Subject: VARIOUS AUDIO SYSTEM CONCERNS WITH TUNER AND AMP UNIT (TAU)	Bulletin No: 09-021/14
	Last Issued: 04/29/2014

- This bulletin supersedes the previous bulletin 09-038/13, issued on 12/19/13 and 12/23/13. The APPLICABLE MODEL(S)/VINS and WARRANTY INFORMATION have been revised.
- Changes are noted below in Red beside the change bar.

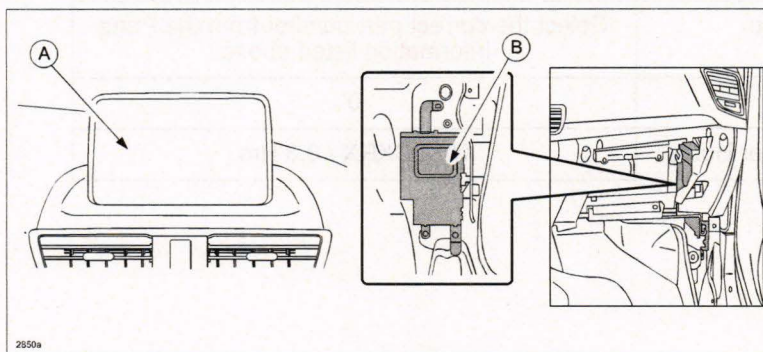
Some vehicle may experience any one of the symptoms below that can be resolved with a modified TAU.

- AM/FM/XM cannot be selected as they are grayed out
- Radio station returns to 87.9MHz on its own
- Audio sound setting resets on its own
- TAU version is displayed as "not available"

1. Verify customer concern.
2. On vehicle with a touchscreen (A), remove the TAU (B) and replace with a modified one. Refer to MS3 online instructions or Workshop manual (section 09-20 TUNER AND AMP UNIT (TAU) REMOVAL/INSTALLATION).
